# Rezoning Transportation Analysis

Petition Number: 2021-112

## Revision Log:

Date	Description
09-21-21	First Review (BKB)

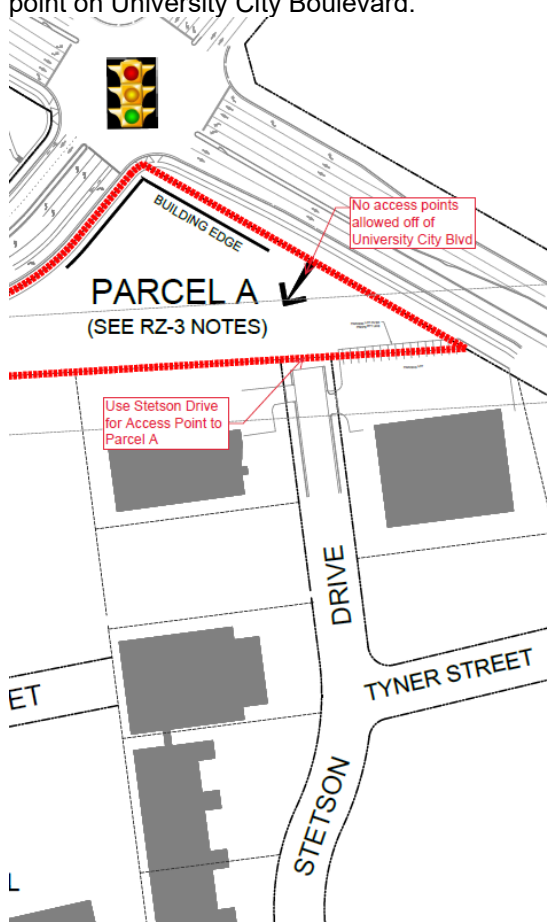
### 1. Traffic Study:

A Traffic Impact Study (TIS) is necessary for the complete review of this petition due to the site generating more than 2,500 daily trips.

Staff will receive the petition and begin review, but the public hearing will not be scheduled until the TIS is approved to allow for the minimum time necessary for CDOT to review the study and reach agreement with the petitioner on the required transportation commitments. Any agreed upon commitments shall be included on the last site plan submitted no fewer than 4 weeks prior to the public hearing. Therefore, additional traffic mitigation comments may be forthcoming once the TIS is approved by CDOT (and NCDOT).
